STAFF REPORT

CITY COUNCIL
DATE: 01/19/2021

TO: Mayor and City Council
FROM: Ken Roberts, Planning Director
AGENDA ITEM: **Schiltgen Farms Revised PUD Concept Plan (10880 Stillwater Boulevard)**
REVIEWED BY: Ken Roberts, Planning Director
Ben Prchal, City Planner
Jack Griffin, City Engineer
Frank Ticknor, Washington County Design Engineer

CONCEPT PLAN

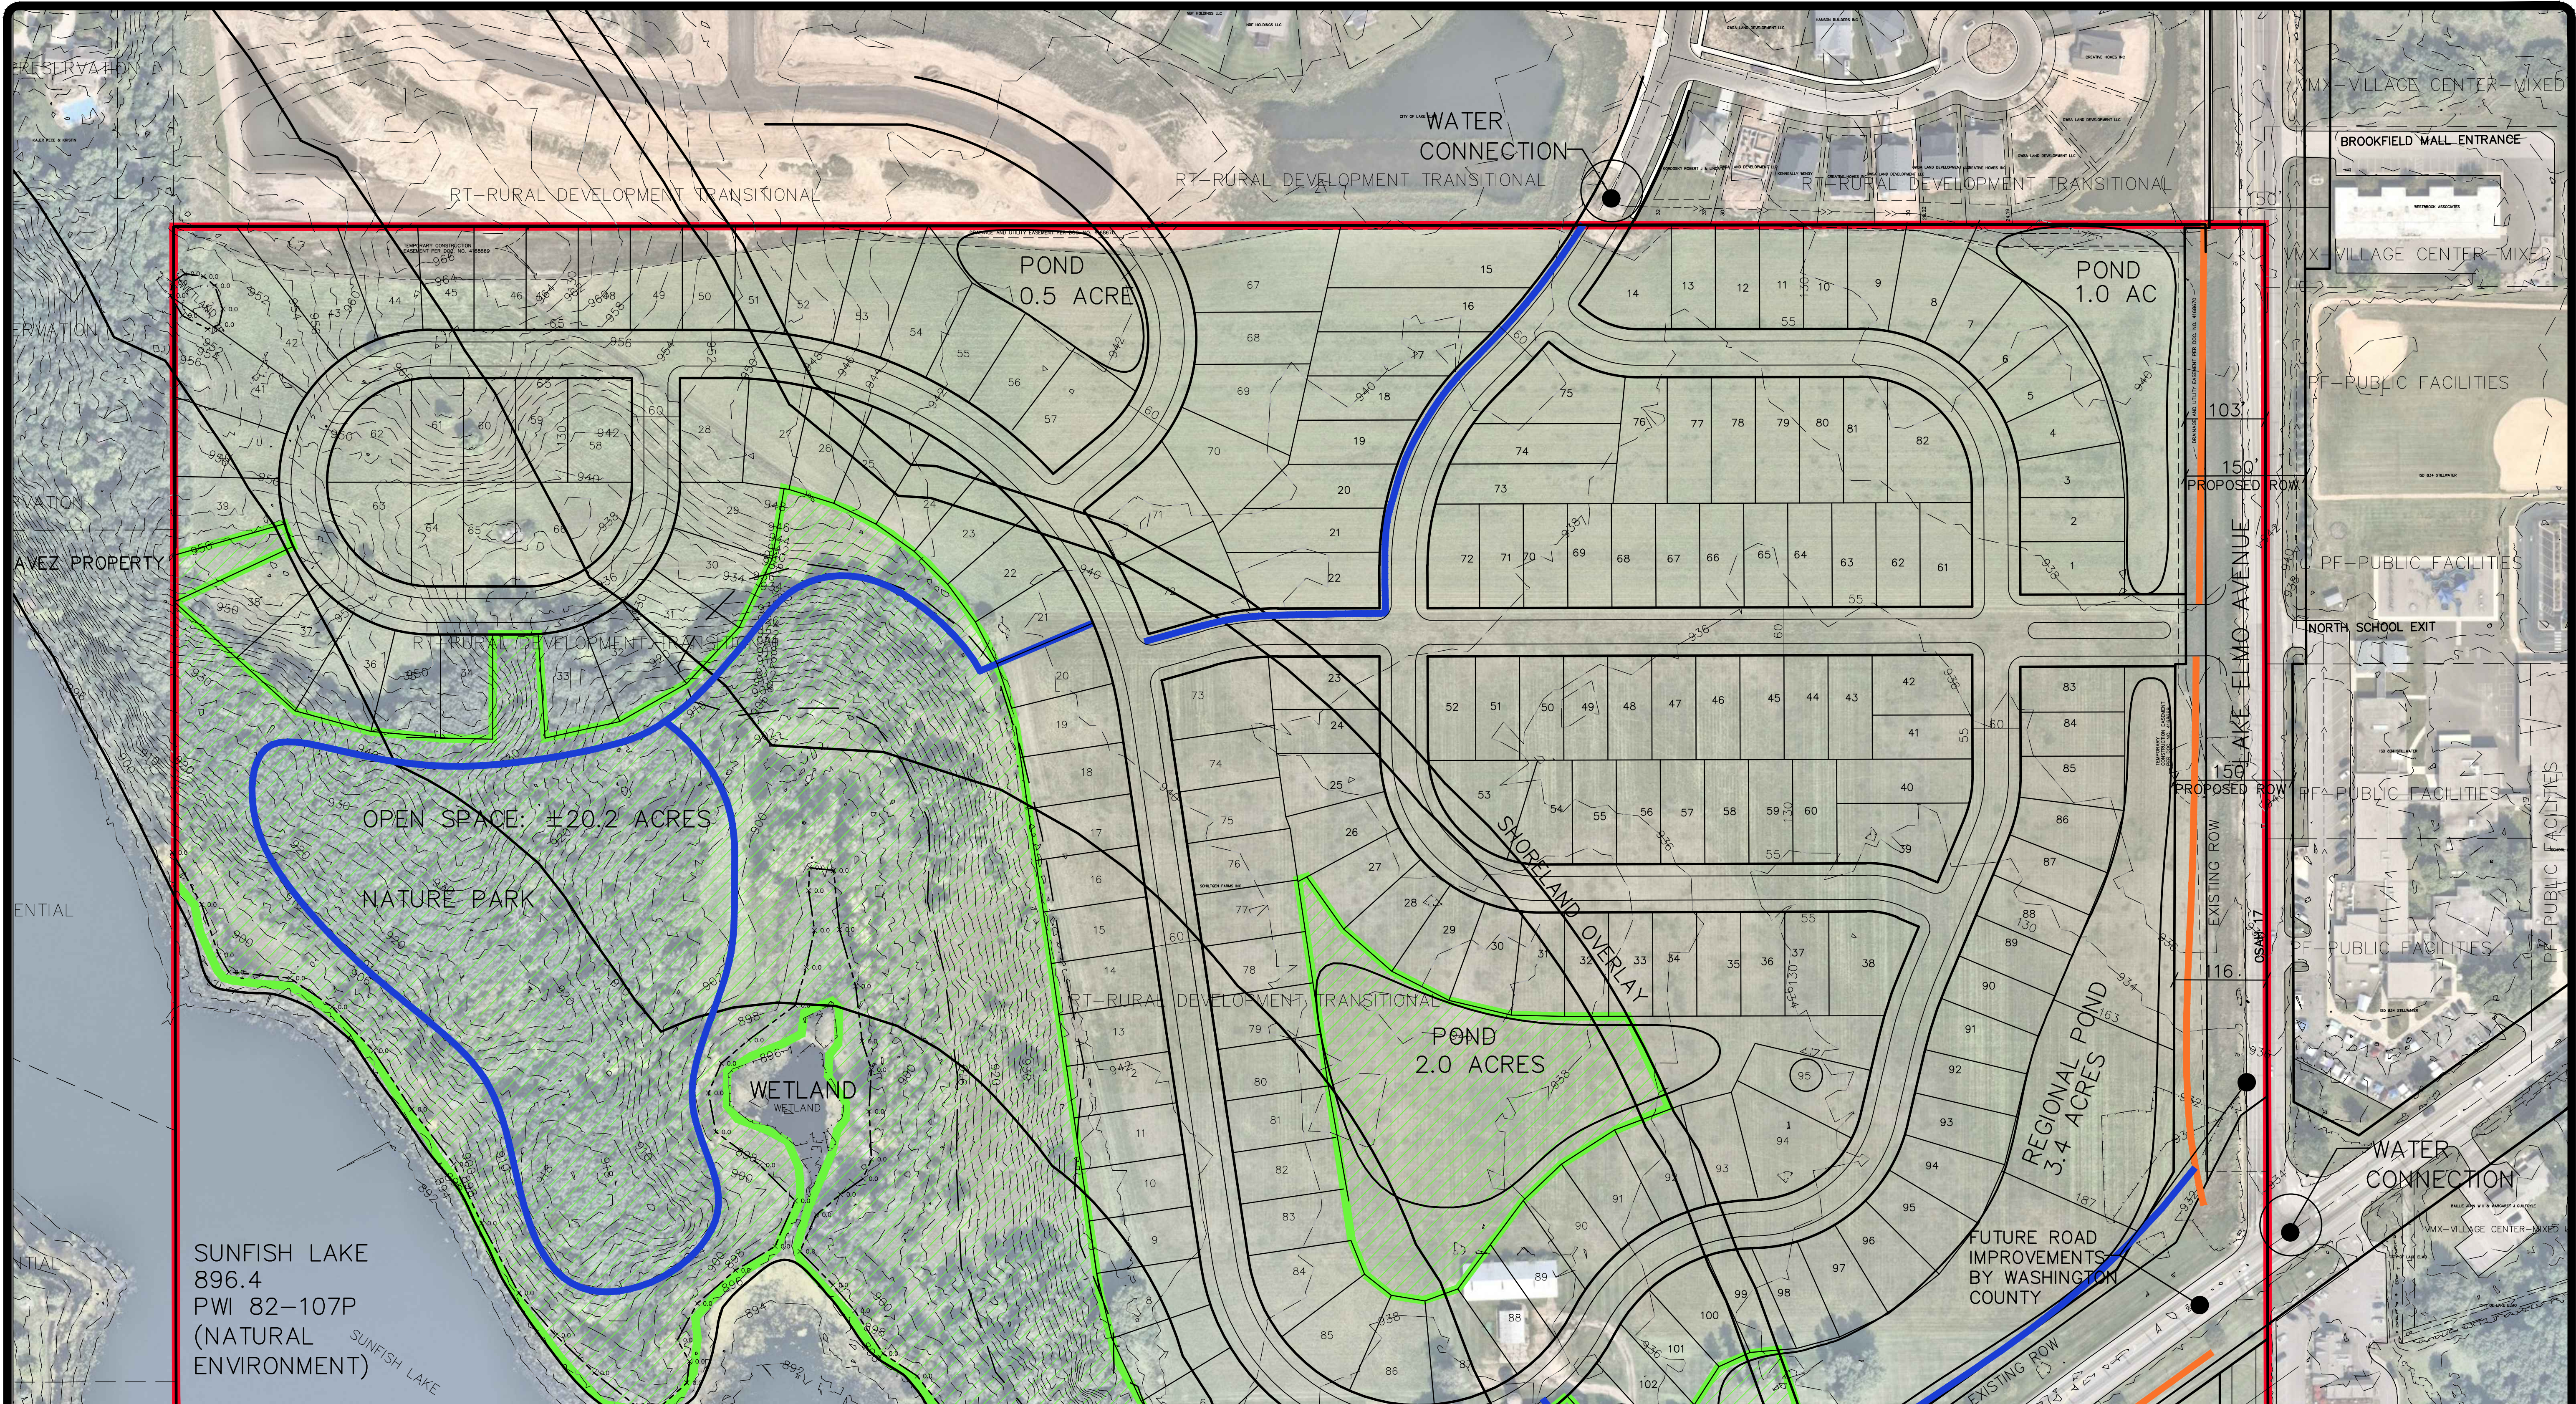
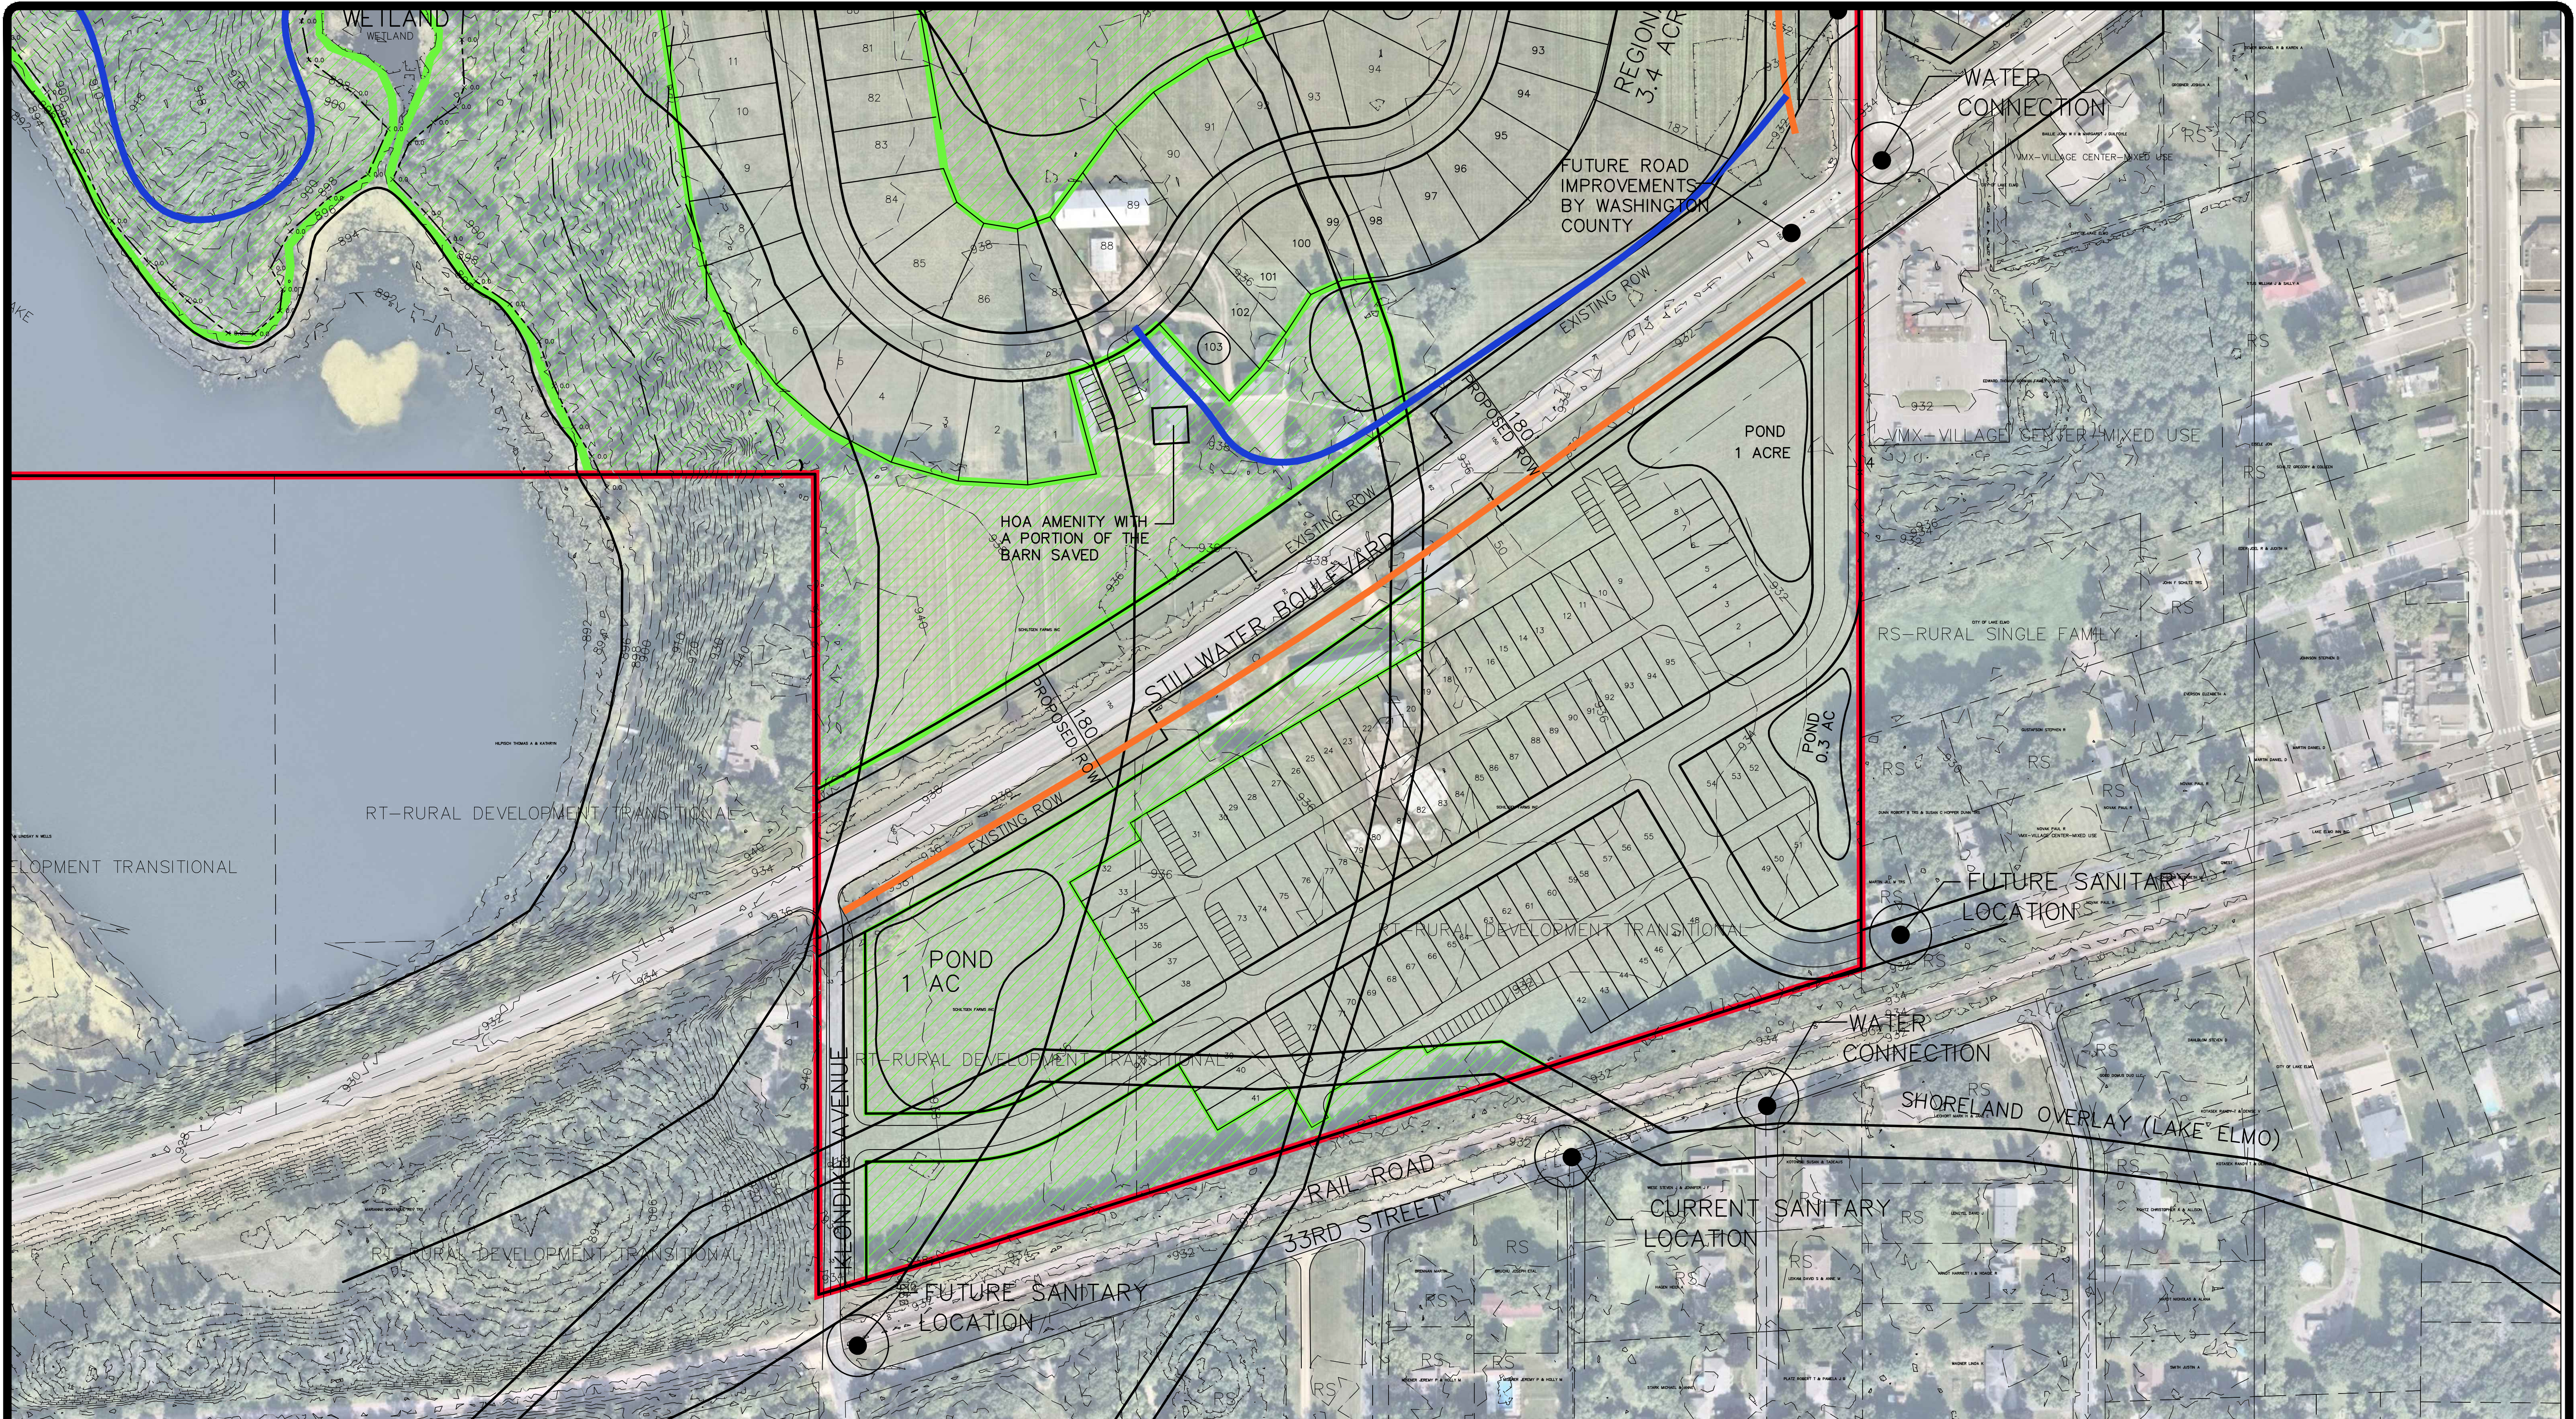
- Adaptive Reuse – 5 points = 5% increase in density
Significant renovation, rehabilitation and adaptive reuse of an existing building(s), rather than demolition. **Note:** The latest PUD concept plan, dated January 7, 2021, shows the developer saving part of the existing barn facing Stillwater Boulevard as part of an HOA amenity with open space surrounding the barn and a small parking area and trail system adjacent to it.

Barn Preservation. The developer noted in its project narrative that they exploring options for preserving part of the barn. The latest concept plans (dated January 7, 2021) show part of the existing barn facing Stillwater Boulevard being preserved with a small parking area and a trail connection in an HOA owned open space area. The City should require the applicant to provide more design details about the potential barn preservation and use (including any off-street parking) with any submittal for preliminary PUD/plat approval. I would expect that if the developer is able to preserve some of the barn that it would be located in a common area owned and maintained by the HOA.

The City Engineer is recommending the City require the developer revise the proposed street plans to delete the cul-de-sac and continue the public street through the site to make a connection to Klondike Avenue. The latest concept plan shows this future street connecting to Klondike Avenue as was suggested by City staff. This street connection would provide an alternate primary access to the development area south of Stillwater Boulevard before the construction of the future roundabout. This street connection will require the developer to make improvements to Klondike Avenue to meet current City street standards together with turn lane and intersection improvements at Stillwater Boulevards as recommended by Washington County. There also may be a need for the developer to dedicate additional right-of-way for Klondike Avenue and for the future roundabout. The proposed Concept plans do not show any changes to Klondike Avenue or to the existing railroad crossing.

The proposed plans also show a public street connection to the southeast corner of the site connecting to Upper 33rd Street on the north side of the railroad tracks. This is consistent with City staff recommendations. The remainder of the streets south of Stillwater Boulevard would be 24-foot-wide private driveways that would provide access to the proposed small-lot single family homes (the detached townhouses).
